**GOVERNMENT/INDUSTRY AERONAUTICAL CHARTING FORUM
INSTRUMENT PROCEDURES GROUP
Meeting 08-01 Arlington, VA
April 22, 2008**

FAA Control # 08-01-280

Subject: Minimum Obstruction Clearance Altitudes Depicted on Standard Instrument Departures (SIDs)

ZEFFR THREE DEPARTURE (RNAV)

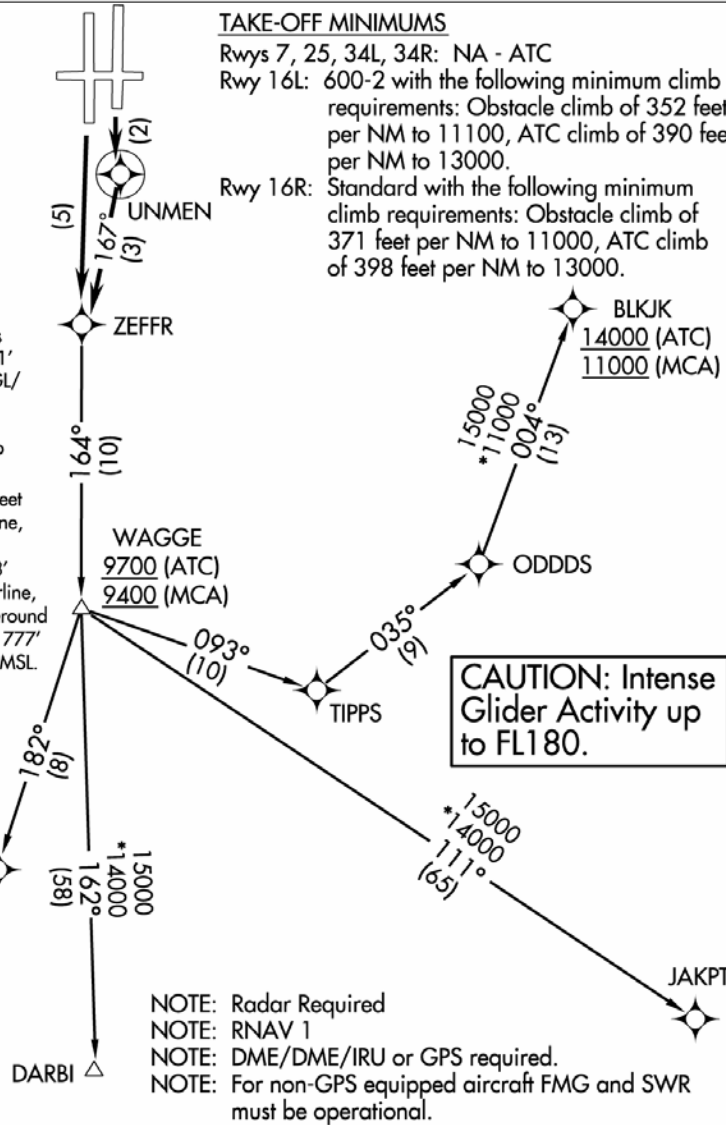
Background/Discussion: FAA Order 8260.46C, Departure Procedure Program, paragraph 10(f)(1), Charting Minimum Altitudes, requires that SIDs (both conventional and RNAV) must depict minimum altitudes for obstruction clearance; and, where appropriate, any required minimum ATC altitudes. Where these differ, documentation of both minimum altitudes is required on the 8260-15 form. Appendix 5 (Non-RNAV DP's) and Appendix 6 (RNAV DP's) of this Order require that SIDs accommodate ATC and obstruction clearance requirements by documenting the ATC altitude followed by the altitude required for obstruction clearance. Charting agencies must depict the obstruction altitude as a minimum crossing altitude (MCA). An example of the application of this requirement may be seen on the attached ZEPHR THREE RNAV SID at Reno, NV (RNO).

Some recently published Graphic DP's fail to depict minimum obstruction clearance altitudes in accordance with the above stated requirements. Two examples of SIDs that do not comply are the EDETH ONE (RNAV) at Salt Lake City, UT (SLC) and the GABRE SIX at Los Angeles, CA (LAX), both of which are attached. Further, there are several other Graphic DPs currently in coordination that also fail to depict the minimum altitudes for obstruction clearance.

All Graphic DP's should be designed and charted in accordance with the criteria contained in FAA Order 8260.46C with respect to fix minimum altitudes for obstruction clearance (MCA) and for air traffic purposes (ATC). Further, the future revision to the 8260.46 Graphic DP's should require the charting of the applicable MOCA for all non-vector procedure legs.

An immediate review of all Graphic DP's published since the issuance of the "C" revision to the 8260.46 Order should be initiated to ensure that minimum crossing altitudes for obstruction clearance are properly charted. Priority should be given to SIDs established at airports located in designated mountainous terrain as specified in 14 CFR 95, Subpart B. Further, all Graphic DP's currently in coordination should also be reviewed for compliance with 8260.46C.

EETH ONE DEPARTURE (RNAV)

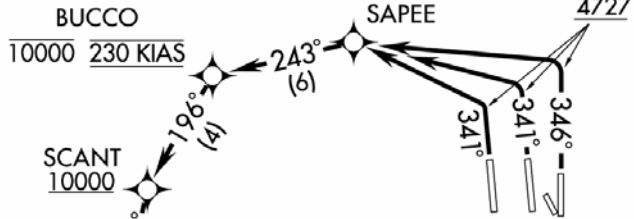
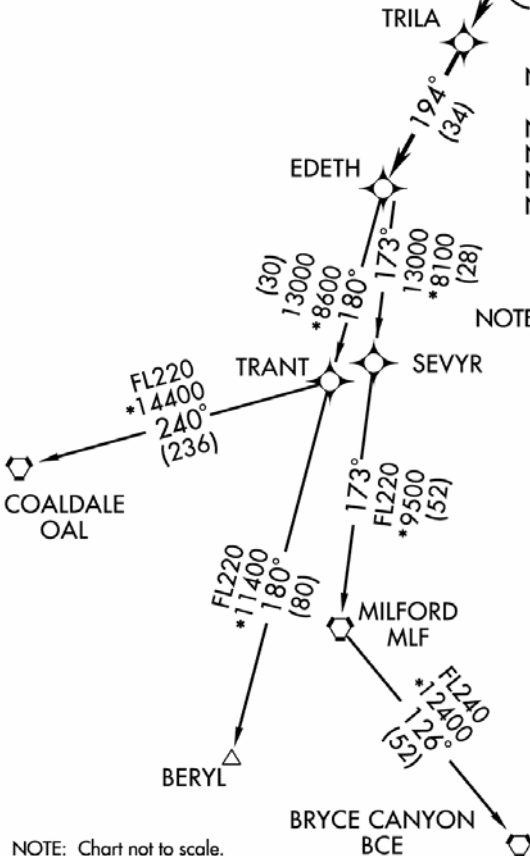
However, the EDETH SID at Salt Lake City (KSLC), which also has obvious ATC and obstacle requirements, does not. Lastly, the GABRE SID at Los Angeles (KLAX) uses an MCA icon (flag) vice the “(MCA)” annotation. Rich also noted that the newly implemented RNAV SIDs at KSLC have experienced numerous altitude violations due to the use of “at or below” initial restrictions. As a result, KSLC TRACON began issuing a hard 10,000’ initial altitude assignment concurrent with the initial ATC clearance. He added that lost communications instructions should be published on the KSLC RNAV SIDs because pilots complying with the initial 10,000’ initial altitude assignment per Part 91.185 may lose obstacle clearance flying these SIDs in the event of lost comm. Rich closed by adding that there may be significant human factors issues associated with current practices. Ted Thompson, Jeppesen, stated that they had historically only charted one altitude; the one which matched the database coding. They are now charting dual altitudes when specified on the procedure source. Kevin stated that the publication of the obstruction clearance altitude is important knowledge for the pilot. He added there is no reason this safety information should only reside with ATC; providing the MCA altitudes to pilots creates a good redundancy in the aviation system. This would be especially helpful if an aircraft lost communications when assigned an altitude lower than a published MCA. Dan Diggins, AJT-22, stated that it is common for controllers to take an aircraft off (both vertically and laterally) an assigned procedure. Rich interjected that when this happens ATC “owns” the aircraft. During the discussion, a suggestion was made that anytime ATC removes an aircraft from a SID they stay removed until in the en route structure. Bill noted that this was also suggested during the discussion of issue 90-02-103; however, ATC rejected this proposal. He then asked the status of the “climb via” phraseology issue. Paul Ewing, AJR-37 (AMTI), stated the issue is still being worked by the RNAV/RNP office. Rich proposed another possible way to handle this issue is to publish MOCAs on all segments of the SID. Brad Rush commented that MOCAs are currently only required on SID transitions. Jaques Beaudry, NAV Canada, pointed out the initial segment MOCA would be higher than the runway so the pilot would be in violation of the MOCA immediately after taking off. Tom confirmed that adding a MOCA along a route where an aircraft is climbing to achieve en route obstacle clearance is impractical and could cause pilot confusion. After much discussion, it was agreed to combine new issue 08-01-280 with this issue and form an ad-hoc working group to resolve all related DP issues to include: Order 8260.46 policy, ATC procedures, AIM revisions, graphic DP charting specifications, using “MCA” on SIDs vs. development of a new designation, etc.. Tom Schneider agreed to chair the working group. A listing of those who signed up to participate in the DP working group is attached here  .
